SRF No. 0148483
County Project No. 091101

CSAH 112 – Phase 1
Project Advisory Committee (PAC) Meeting
February 18, 2015; 8:00 am – 10:00 am
Orono City Hall
MEETING RECORD

Retaining Wall Aesthetics - Modular Block Walls - Option A

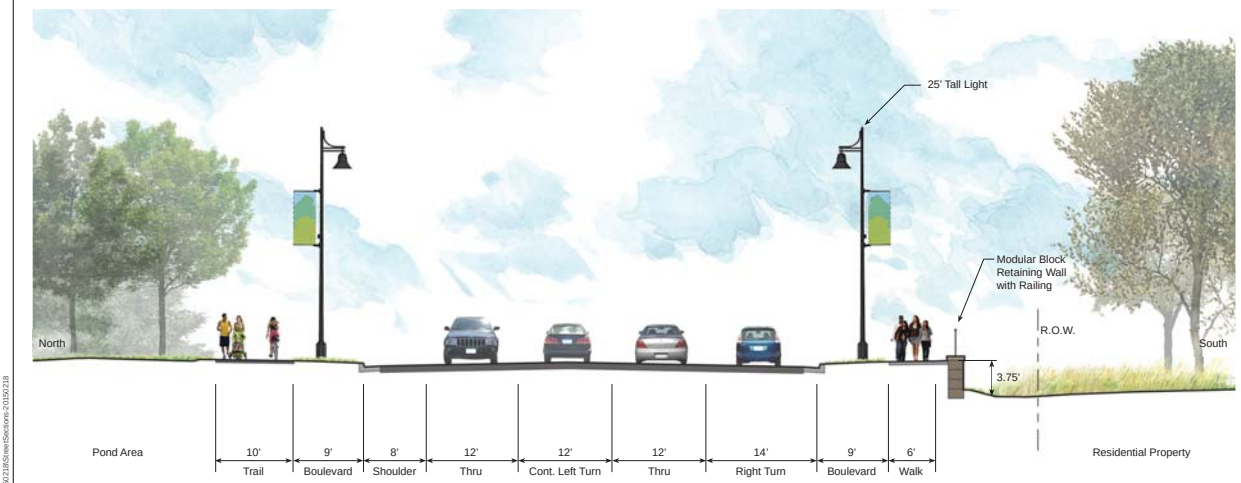
Michael explained raw concrete appearance of both wall types and the recommendation to use a 3-color stain surface treatment for the stone textured areas and the single color finish for the non-textured areas. It was noted that the 3-color and single-color approach has been used successfully on other Hennepin County projects including the CIP walls along CSAH 101 between County Road 6 and County Road 24 in Plymouth. Michael noted that during construction of the walls, the specifications would require the contractor to build mock ups of both the CIP and large block walls including the color stain application for acceptance by all parties.

After discussion, the PAC was agreeable to the proposed recommendations for texturing and color systems.

Marv Wurzer inquired if there was a way construct a short height curb or barrier adjacent to the exposed retaining wall face to reduce the nicks and scratches that occur from plowing the trails/walks with the City's pickup mounted plow. Mike Turner provided some additional considerations should an integral curb or separated curb be considered it may have negative impacts on the available trail/pedestrian widths resulting in additional right of way costs.

Streetscape Cross Section 1 (West of Brown Road)
CSAH 112 Final Design
Hennepin County

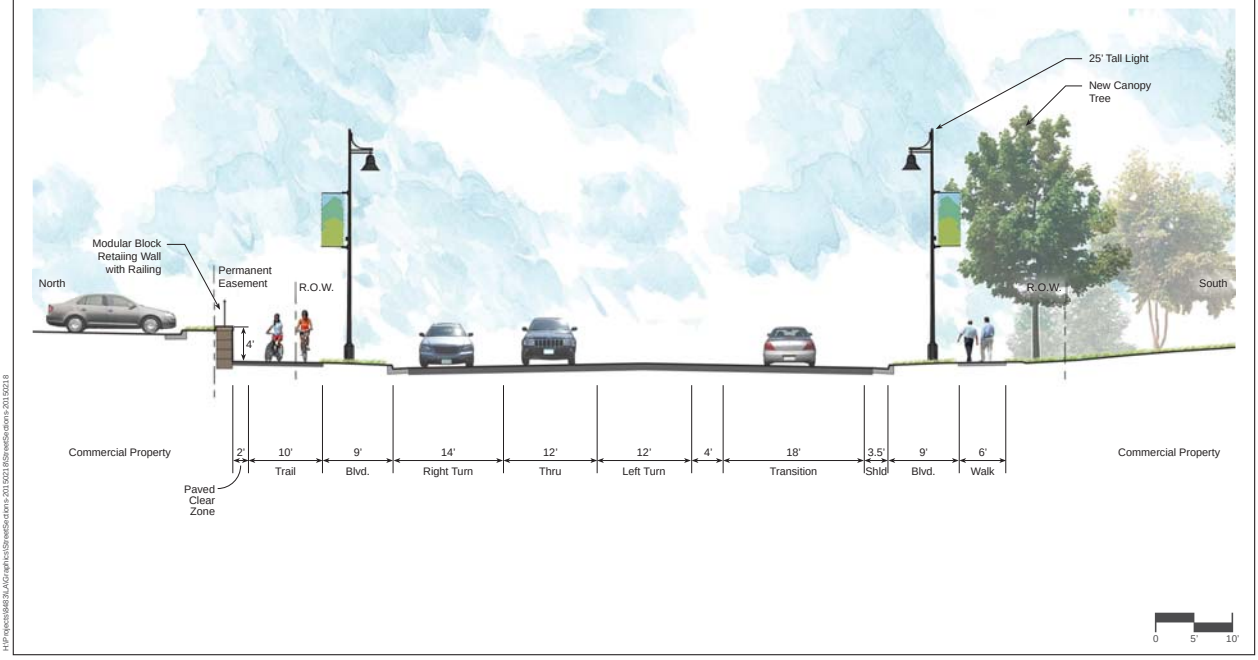
Michael Jischke presented the draft streetscape layout focused on a portion of the Phase 1 project area from Brown Road to the Luce Line Trail connection. A copy of this graphic is attached to this meeting record. Using this layout, he presented several other graphics (attached herein) to illustrate typical sections (looking east along CSAH 112) and proposed streetscape features.

Streetscape Cross Section 3 (West of Lake Street)

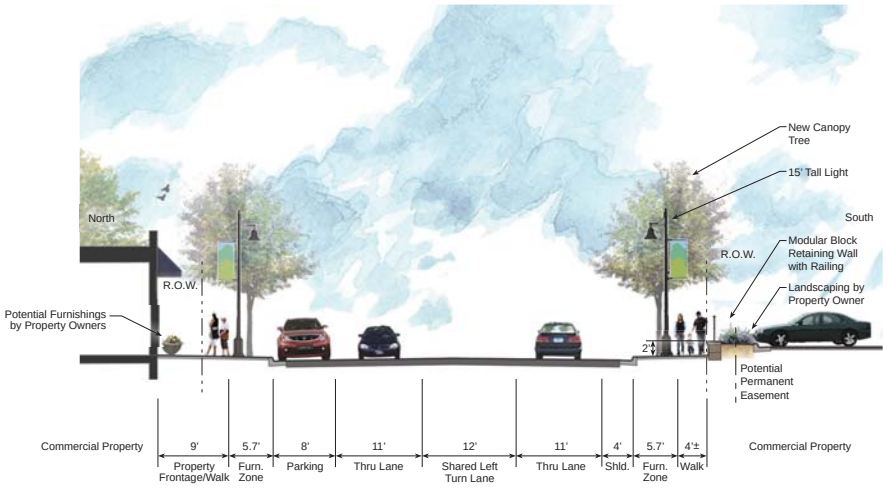
A discussion occurred regarding the proposed parking lane width of 8 feet from Lake Street to Martha Lane. Mike Turner mentioned that one of the reasons the County was proposing the 8-foot parking lane width to increase the adjacent walk areas for trees and furnishings and the by doing so, the County was seeking a variance from State Aid requirements. The minimum requirement for parking along this type of roadway is 10 feet.

After some further discussion, and based upon the decision to remove trees along the north side, the group discussed increasing the parking lane from 8 feet to 10 feet. Marv Wurzer favors the wider parking area for snow removal operations which include loading and hauling the snow from the parking area and walks. After some additional discussion, the majority of the PAC agreed to increase the parking width to 10 feet.

Village Center Gateway Concept
CSAH 112 Final Design
Hennepin County

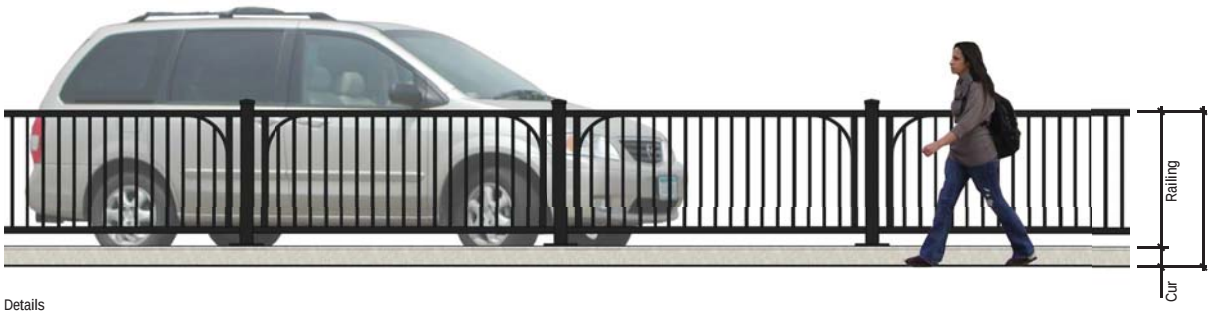
Gateway Monuments:
Michael presented another graphic showing a concept of the "Village Center Gateway". A copy of this graphic is attached to this meeting record. He explained how the monument would complement the colors and features from the proposed retaining walls and railings. Michael pointed out the two (2) proposed locations for these monuments as follows: 1) in the southeast corner of the Brown Road/CSAH 112 intersection; and 2) on the south side of CSAH 112 near at the confluence of the Long Lake City Trail connection to CSAH 112 along the lake. It was noted that typically on these types of monuments, especially those located within the County right of way, that Hennepin County may require acknowledgement on the plaque.

Donny suggested the Long Lake logo be incorporated into monument plaque. The PAC discussed the viewing locations of both monuments and agreed that the locations proposed represent the optimum viewing for motorists on CSAH 112. Others preferred using text only and not including logos since they are often subject to change.

Donny mentioned the existing Long Lake wooden monument, located near Cemetery Road/CSAH 112, is in poor shape and the City might consider replacing the monument. Nate Will mentioned this existing monument falls within the proposed stormwater treatment "dry" pond and was planning to be salvaged or removed.

The PAC briefly discussed a comparable monument being proposed in the northwest corner of Brown Road at CSAH 112; however, Michael pointed out that corner has numerous existing utilities and a stormwater overflow structure. Orono representatives expressed interest in potentially building a similar feature in a future phase of the project at Old Crystal Bay Road. The PAC requested some additional aesthetic options for comparison at the next meeting.

Village Center Ornamental ence Concept
CSAH 112 Final Design
Hennepin County

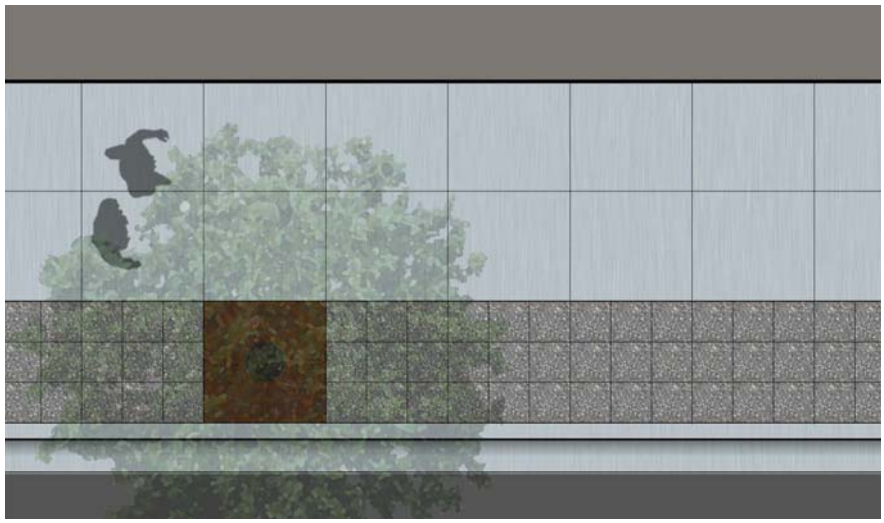
Ornamental Fence (at Parking Lot Edges):
Michael described the intent of the fence would be to define the walkway edge and visually screen vehicles. The construction of the proposed fence would be similar to a standard bridge railing and painted black. A copy of these graphics are attached to this meeting record. He also pointed out the additional aesthetic "arcs" that reference the architectural detailing of the Long Lake City Hall roof. It was noted that this project, CSAH 112 Phase 1, will be used as a precedent in designing retaining walls and railing types completed under future Phase 2 and Phase 3. The PAC requested some additional aesthetic options for comparison at the next meeting.

Donny Chillstrom suggested using a fence along CSAH 112, in front of the liquor store, to provide some added delineation. Michael noted that idea was included in the preliminary planning and is also being incorporated into the final design near the Birch's Restaurant and at the northeast corner of the Lake Street intersection.

Downtown Street Scape
CSAH 12 Final Design
Hennepin County
DRAFT

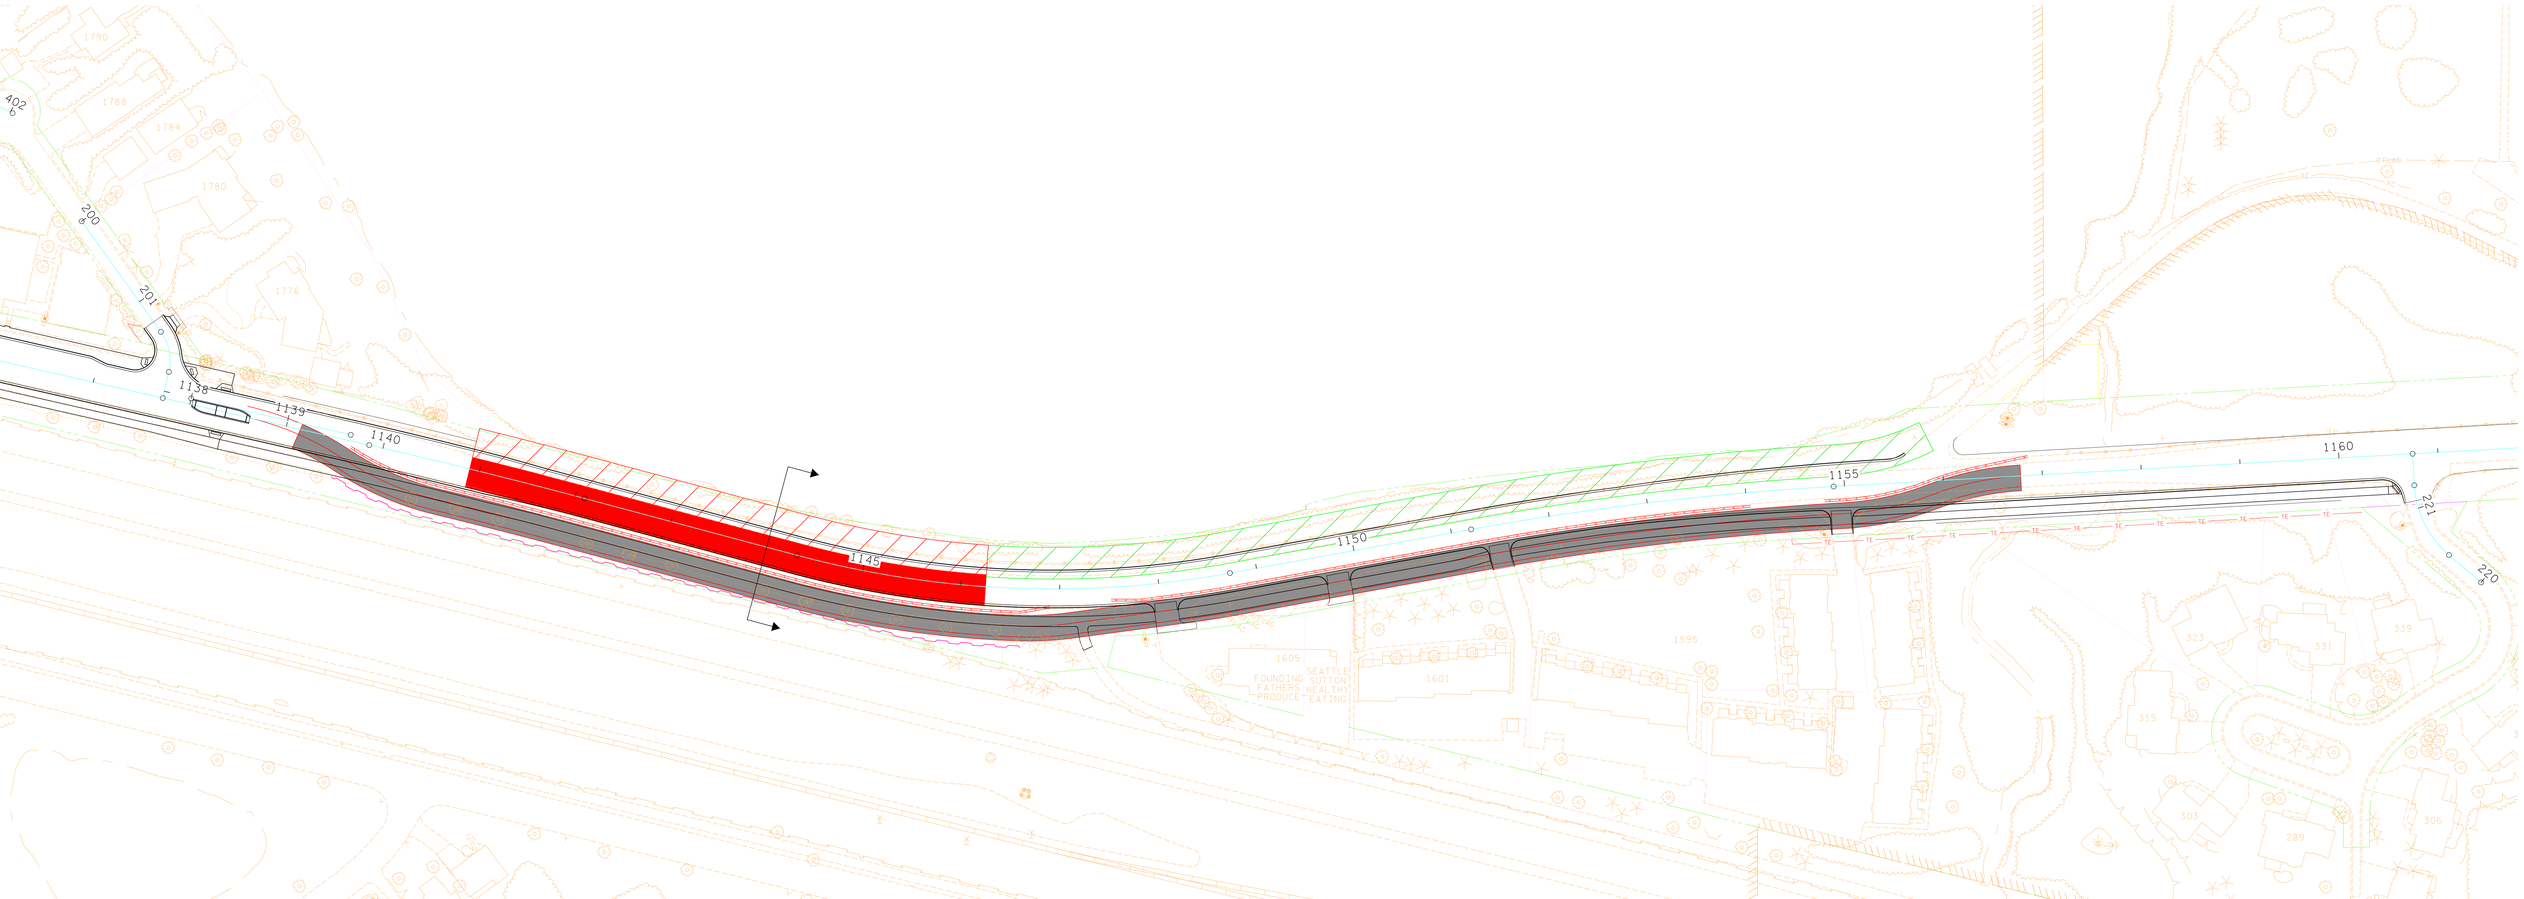
Nate Will presented a layout graphic showing the downtown area of Long Lake, including Lake, Symes and Mill Street. He refreshed the PAC on the decision to construct a trail along Lake Street and extend a 6-foot concrete walk along a portion of Symes Street. He also pointed out the proposed trail extension from Mill Street to Martha lane. Nate described the existing lighting along Lake, Symes and Mill Streets which consists mostly of cobra style light extensions attached to existing electrical poles at areas indicated on the graphic.

Nate asked if the PAC, primarily the City of Long Lake, desired to have a different level of lighting along these streets for the trail users. The representatives from Long Lake felt strongly that an upgrade of the lighting along these streets, including lighting of the ends of the trail connection between Mill and Martha, should be considered in the project. Donny Chillstrom mentioned several years ago, the City of Long Lake had developed a sketch showing what the proposed lighting might include. He offered to send SRF the sketch for review and refinement.

Nate mentioned that one option would be to re-install some of the salvaged lights (green Washington style), that are being impacted in Phase 1, to use along Lake, Symes and the trail connection. The City of Long Lake was acceptable of this option rather than upgrading to the LED lights proposed along CSAH 112.

REINFORCED SOIL SLOPE - PRELIMINARY SECTION WITH TEMPORARY BYPASS ROAD

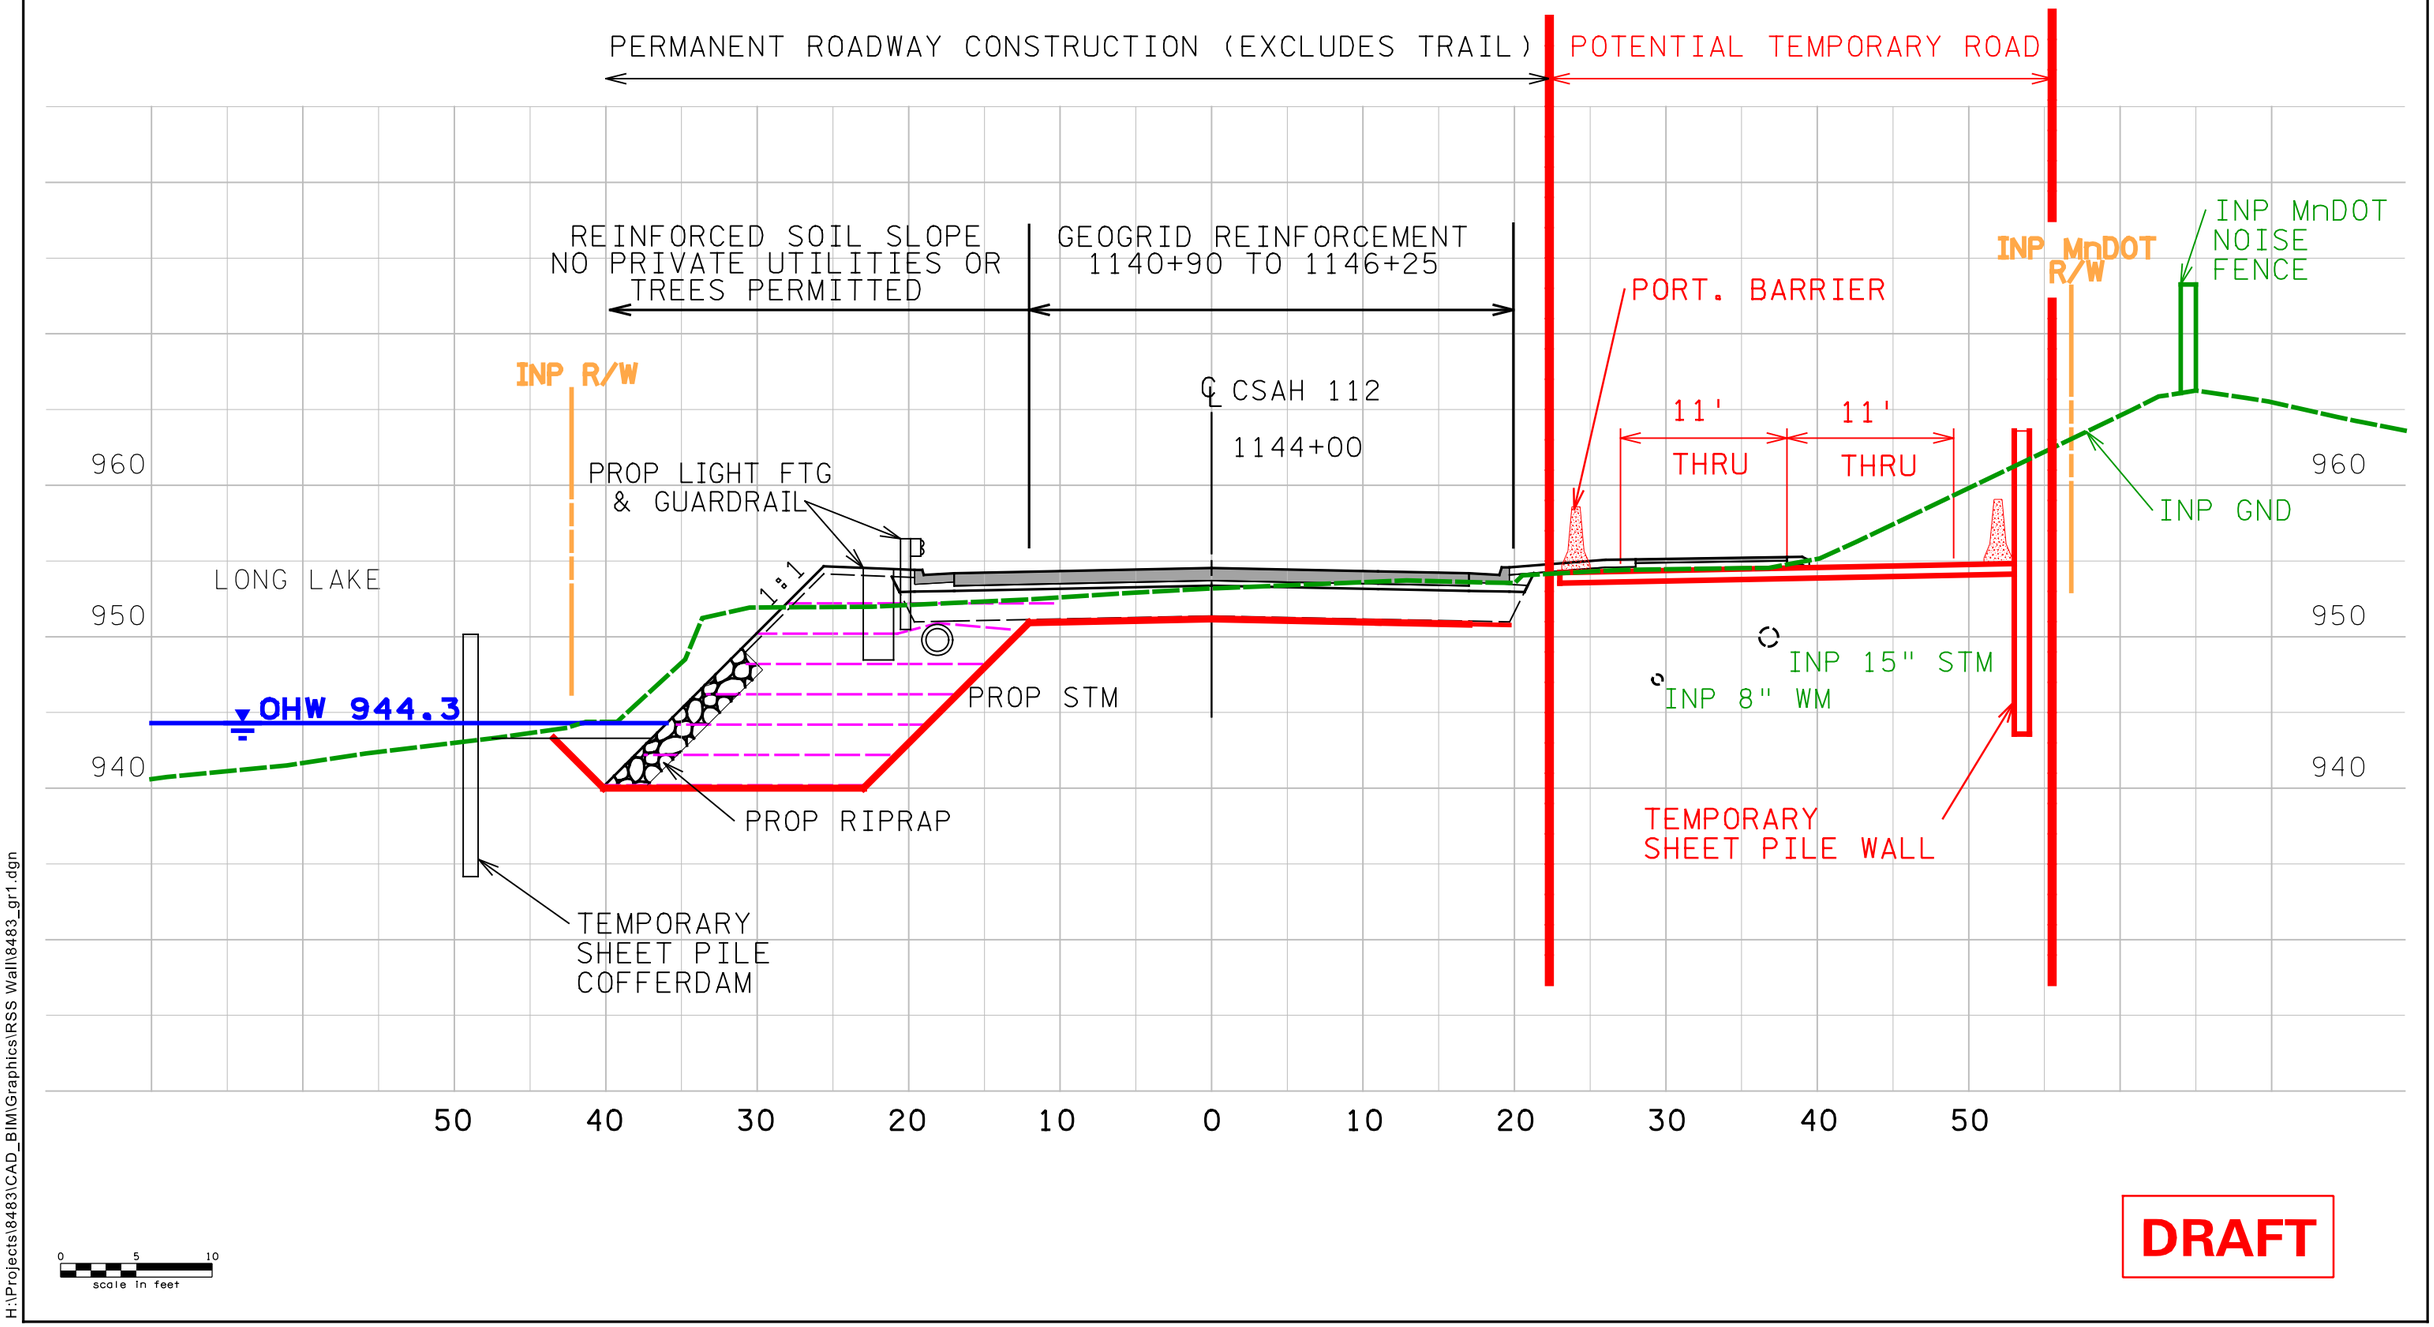
Nate presented a graphic that was previously shown to the PAC with additional details on how a temporary roadway might be constructed to bypass around the area where the proposed lake shore restoration will occur. A copy of the graphic presented is attached to this meeting record.

Nate explained the extent of the proposed impacts to the existing berm that separates CSAH 112 from TH 12 which requires a temporary sheet pile wall, pavement and potentially impacts underground utilities. Nate indicated that a preliminary cost estimate was developed totaling nearly $800,000 for the temporary bypass. It was also noted that additional construction time including impacts to traffic would result to construct the temporary bypass versus implementing a full closure of CSAH 112 during the shoreline restoration.
